PRODUCT/PROCESS CHANGE NOTIFICATION

PCN MMS-MIC/14/8385
Dated 10 Jul 2014

**UFBGA Transfer back-end site from Amkor ATK (Korea) to
Amkor ATP (Philippines) & Features improvement for
STM32F42xIxH & STM32F43xIxH products**

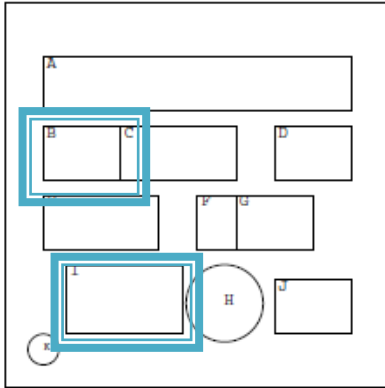
How can the change be seen?

The marking composition indicated on the products is changing:

B : Assy plant
changes from HP to 7B

I : Country Of Origin
changes from KOR to PHL
